R19ZV

IMPORTANT SAFETY RECALL NOTICE

SUBJECT: RECALL R19ZV – Vision Transmission Shifter Cable and Brake Line Routing with Ford 6.8L V10 Engines

R19ZV Revision A Vision Trans Shifter Cable & Brake Line

Photo 1

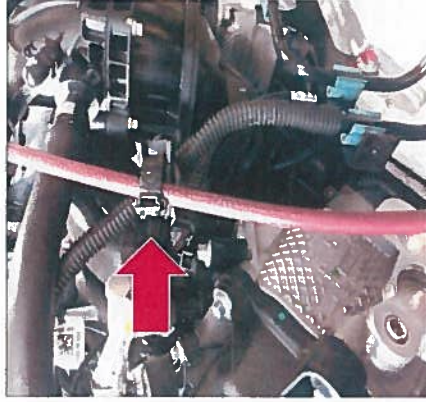
Check the transmission shifter cable and insure it is NOT mounted to the top rear of the engine (Photo 1). Also inspect the fuel line to insure the PCV hose is not attached to the fuel line (Photo 2). If so, cut the mounting cable ties and remove ties and mounting saddle. Inspect the fuel line for any chaffing at shifter cable mounting point and replace fuel line if necessary.

Figure 1

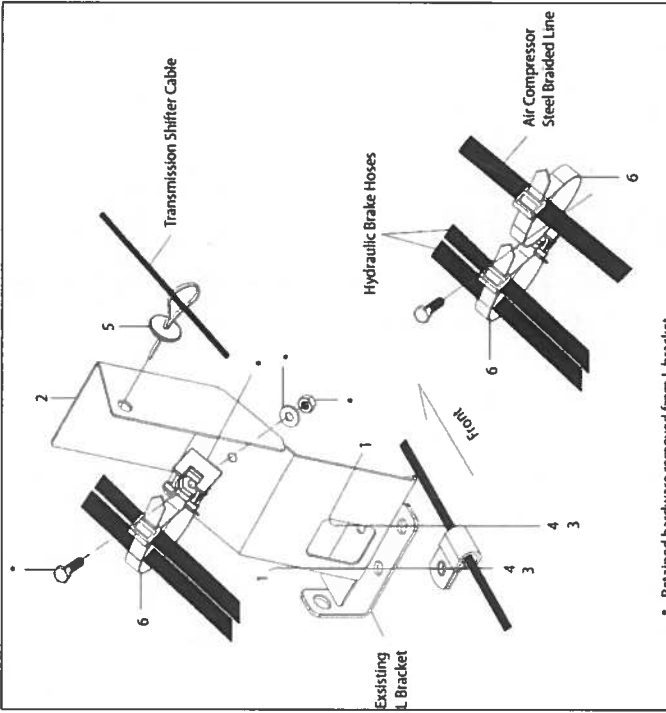
4. Locate the existing steel brake line L bracket mounted to the inside of the LH frame rail. Remove and retain the hydraulic brake line clamp, two-way saddle and fasteners from the top of the L bracket (Figure 1).

5. Install heat shield bracket (Item 2) to the top of the L bracket with fasteners (Items 1, 3, 4) and remount the metal brake line clamp under the existing L bracket (Figure 1).

- Please insure steel brake line is clamped in a parallel line to the frame rail.
 6. Install the previously removed two-way saddle containing the rubber hydraulic brake line to the heat shield using the existing fasteners as shown (Figure 1).

7. On units with an air compressor, secure the air compressor steel braided line to the heat shield saddle with an additional tie cable (Item 6) separate of hydraulic brake lines as shown (Figure 1).

- Verify the routing of the braided line to insure no dips in the line with a continuous downward slope to the air dryer.
 8. Secure the transmission shifter cable to the side of the heat shield with button head zip tie (Item 5) as shown (Figure 1).

Figure 2

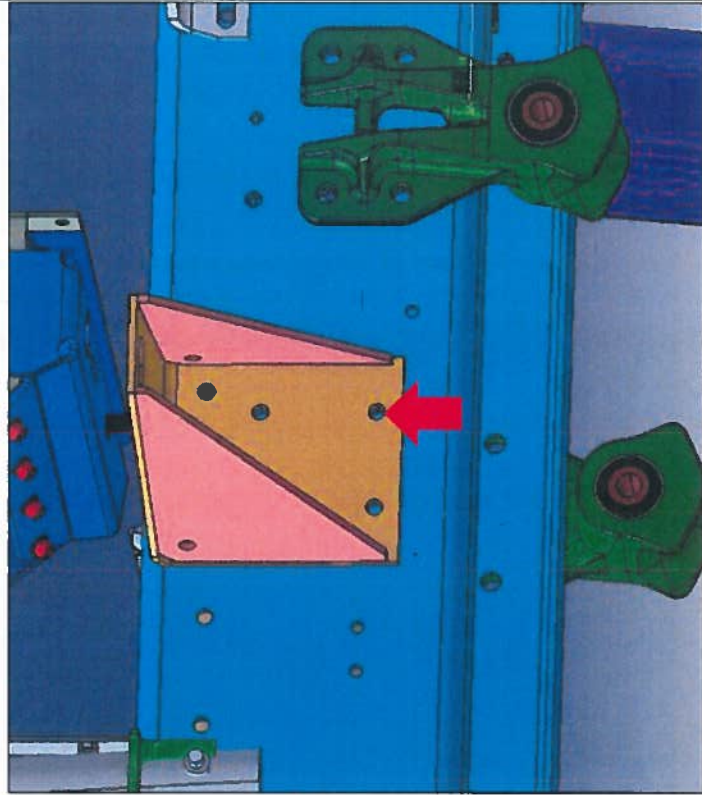
1. Locate and remove lower rearward Huck fastener from driver's side outrigger bracket. Indicated with small red arrow (Figure 2).
2. Install L bracket (Item 7) with fasteners (Items 8, 9, 10) on the inside of frame rail in the location of the removed Huck fastener. Torque to 56-58 ft lbs.

Figure 3

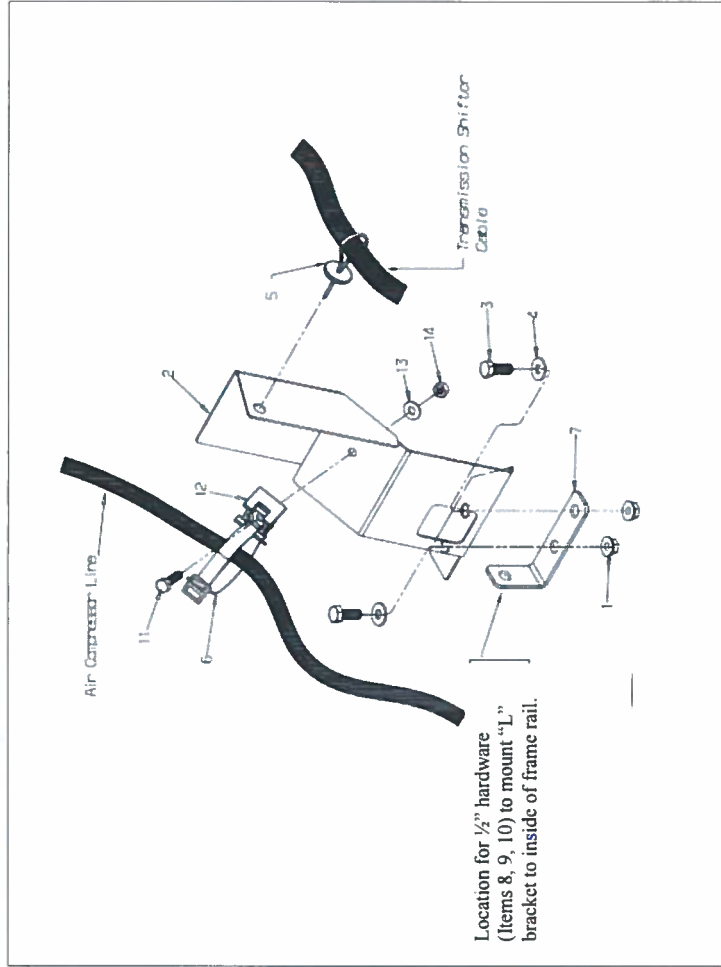
3. Install heat shield bracket (Item 2) to the top of the L bracket with fasteners (Items 1, 3, 4) as shown (Figure 3).
4. Install Saddle (Item 12) to the heat shield with fasteners (Items 11, 13, 14) as shown. Secure the air compressor steel braided line to the heat shield saddle using Zip Tie (Item 6) as shown (Figure 3).

- Verify the routing of the braided line to insure no dips in the line with a continuous downward slope to the air dryer.
5. Secure the transmission shifter cable to the side of the heat shield with button head zip tie (Item 5) as shown in (Figure 3).
